INSTALLATION OF CUSHION BARRIER
AT LUNALILO FRWY - VINEYARD (OFF-RAMP)
& STA. 83+00
SAFETY IMPROVEMENTS ALONG
INTERSTATE H-1
KALIHI ST. TO PALI HIGHWAY
Proj. No. I-HI-1(112):19 Date: April, 1973

STATE OF HAWAII
DEPARTMENT OF TRANSPORTATION
HIGHWAYS DIVISION
INSTALLATION OF CUSHION BARRIER
AT LUNALILO FRWY. & RAMP "5"
@ Sta. 103+50
SAFETY IMPROVEMENTS ALONG
INTERSTATE H-1
KALIHI ST. TO PALI HIGHWAY
Proj. No. I-H-1(112)19 DATE: April, 1973

C. O. 45

SAFETY IMPROVEMENTS ALONG
INTERSTATE H-1
KALIHI ST. TO PALI HIGHWAY

STATE OF HAWAII
DEPARTMENT OF TRANSPORTATION
HIGHWAYS DIVISION
INSTALLATION OF CUSHION BARRIER
AT LUNALILO FRWY-SCHOOL ST (OFF-RAMP)
Sta. 132+75
SAFETY IMPROVEMENTS ALONG
INTERSTATE H-1
KALIHI ST. TO PALI HIGHWAY
Proj. No. I-HI-1(12):19 Date: April, 1973
SHEET No. 90 OF 110 SHEETS

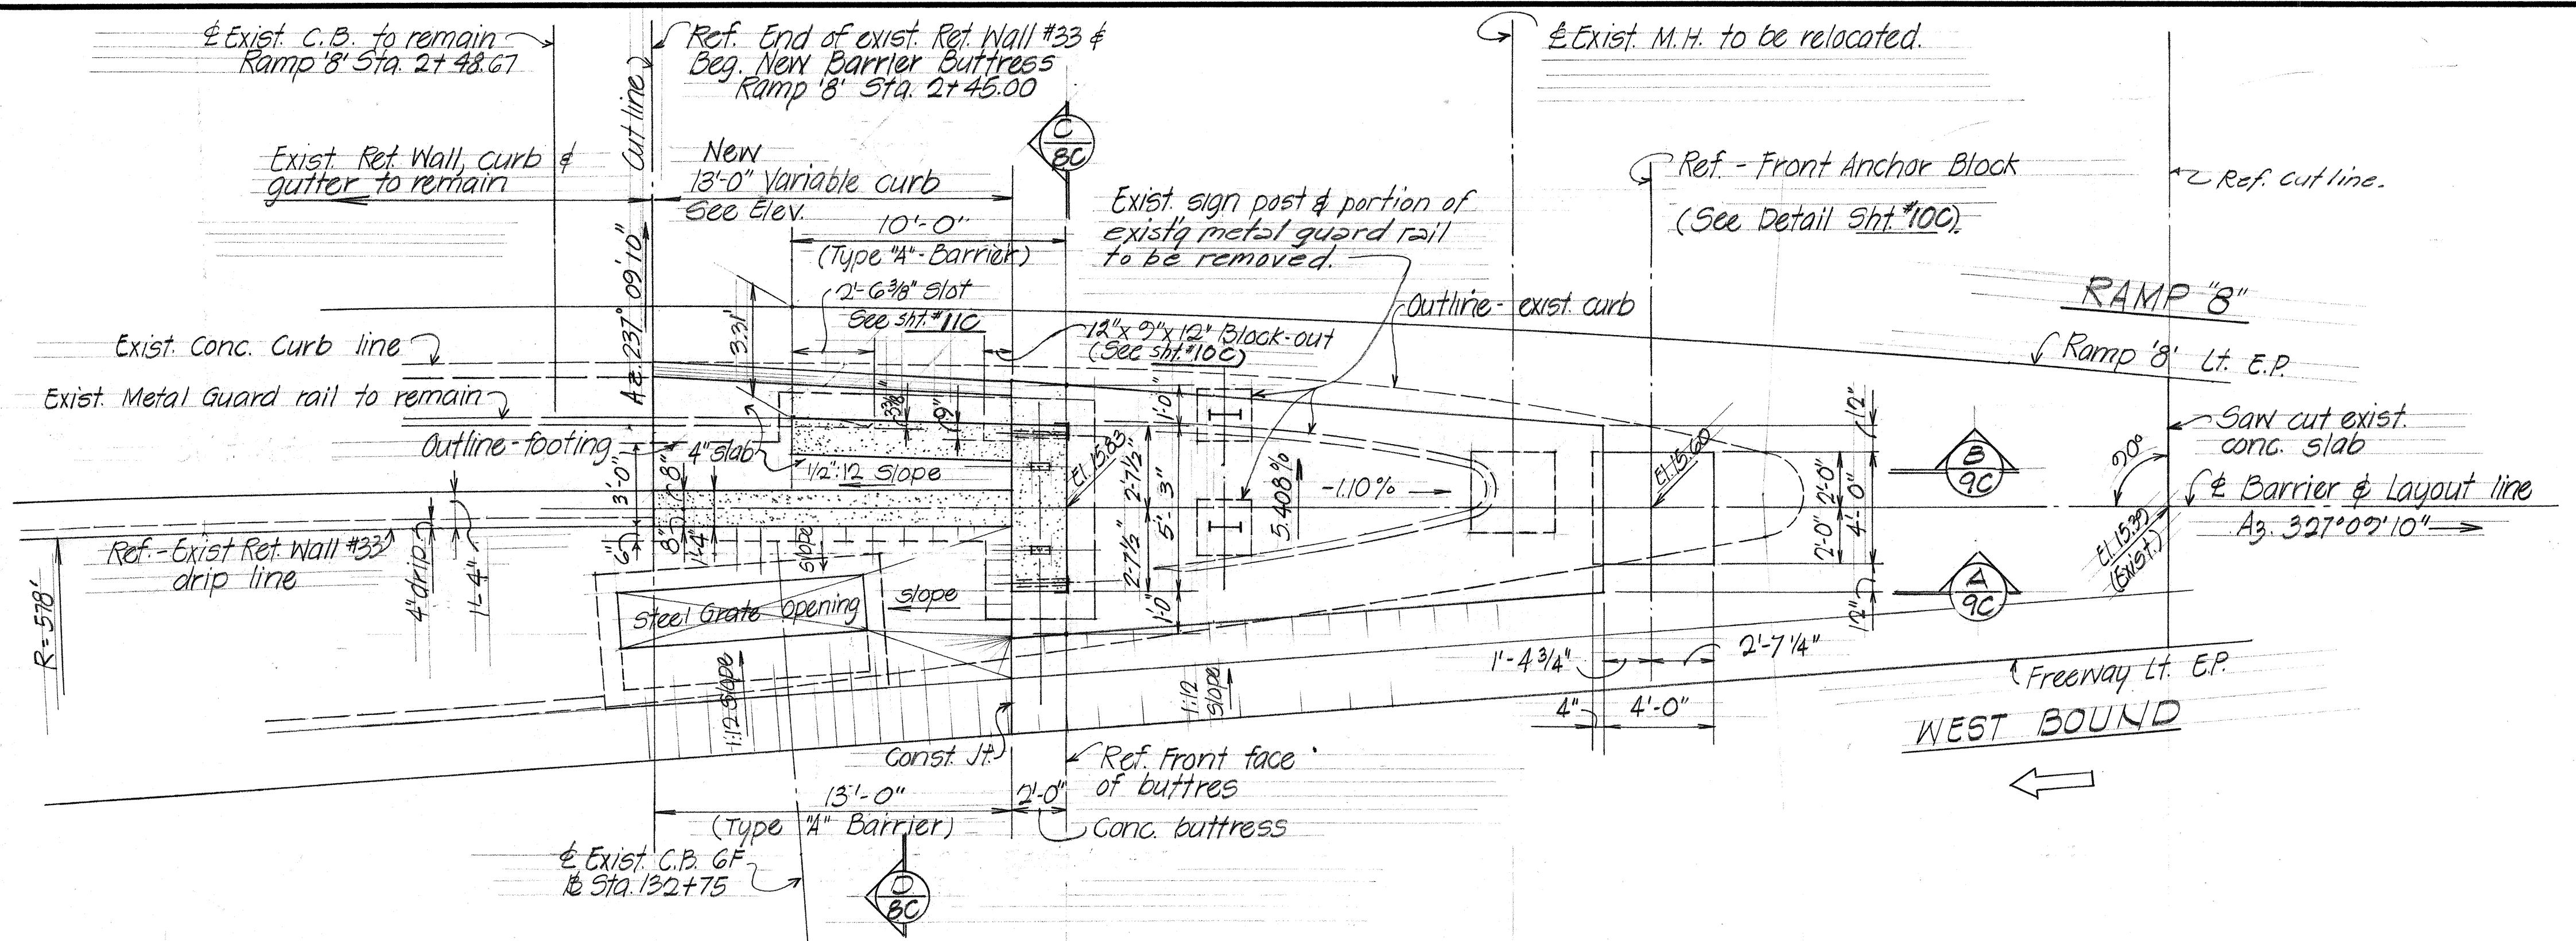
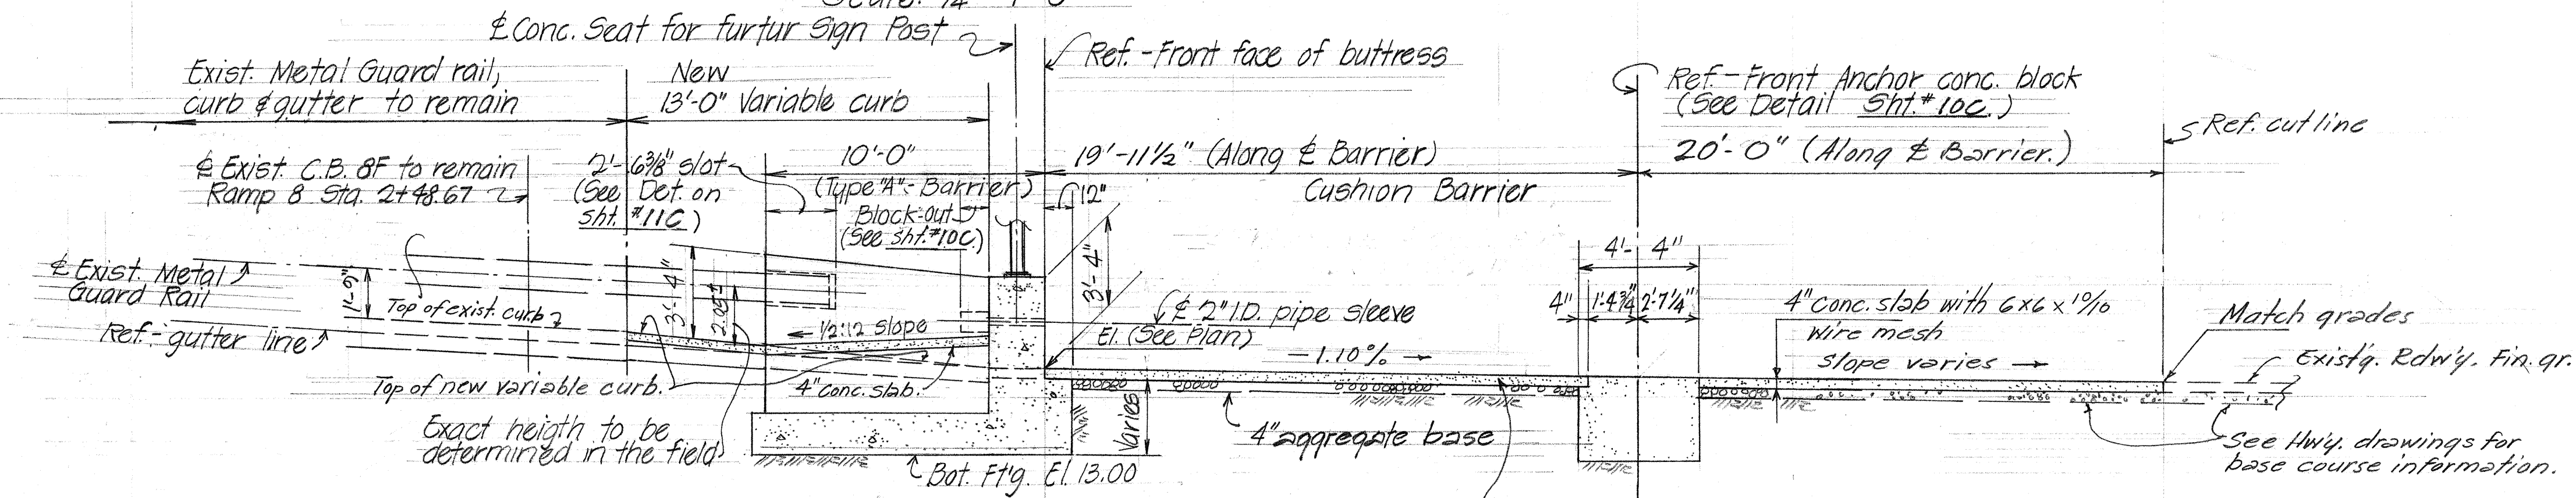
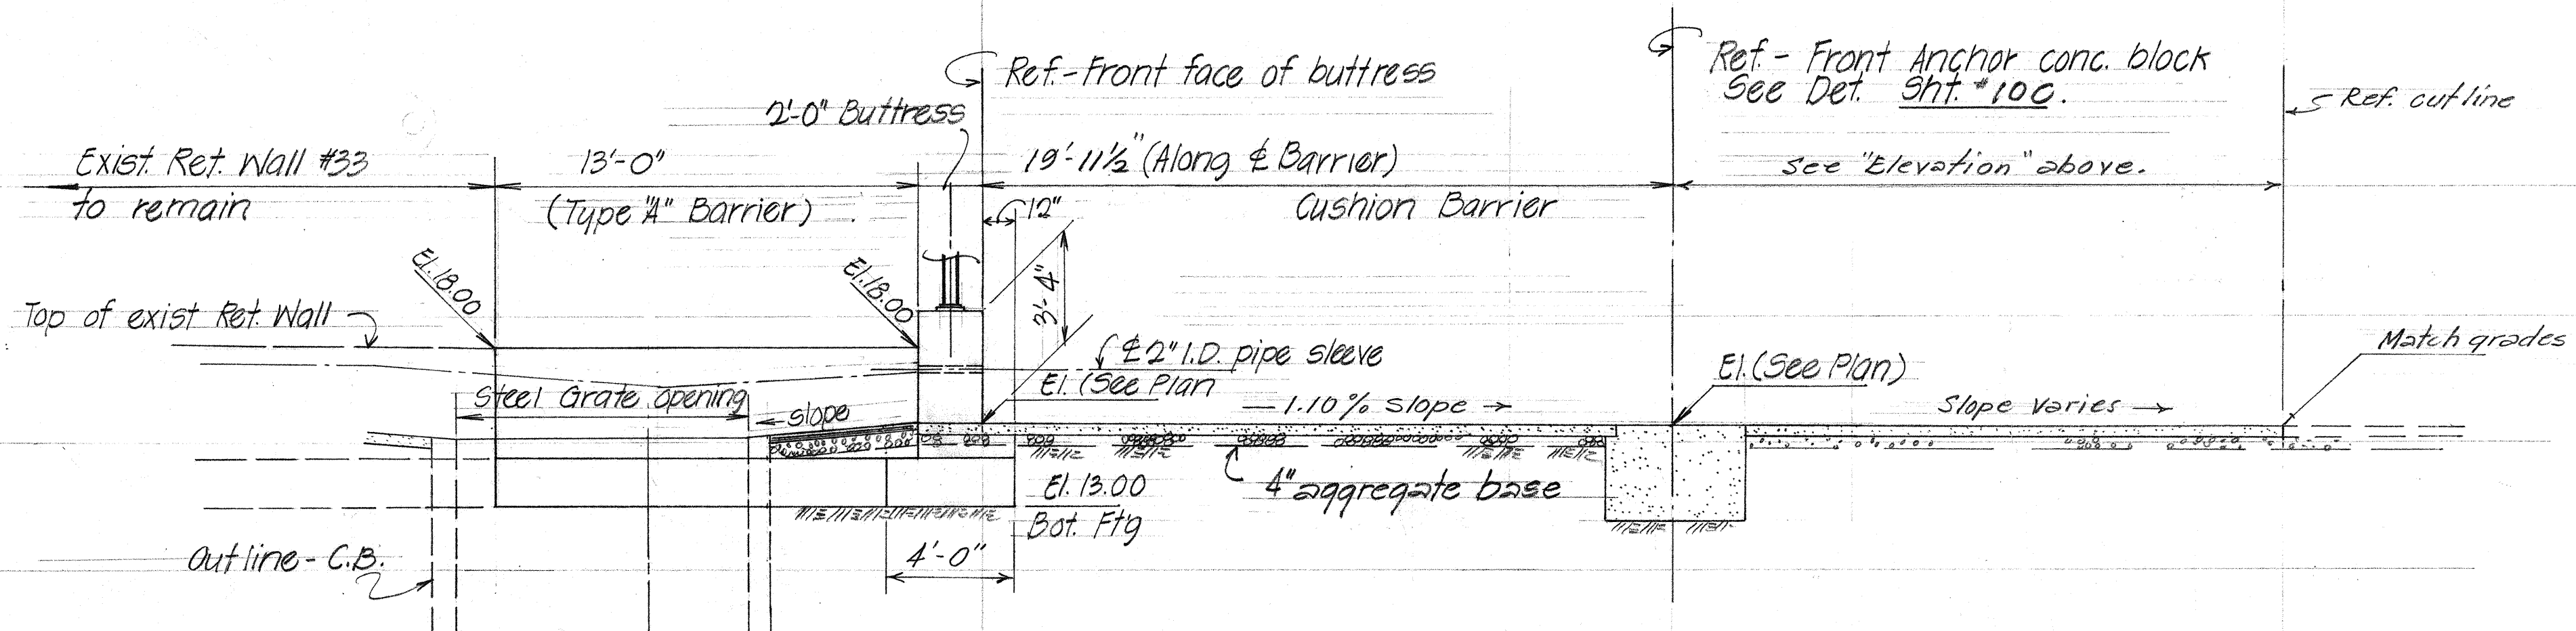
12-6-74 Buttness width changed from 7'-0" to 5'-3" and restraining cable 2"φ sleeve location revised accordingly. Length of unit changed from 21'-2 1/4" to 19'-11 1/2" and block out dimension changed.
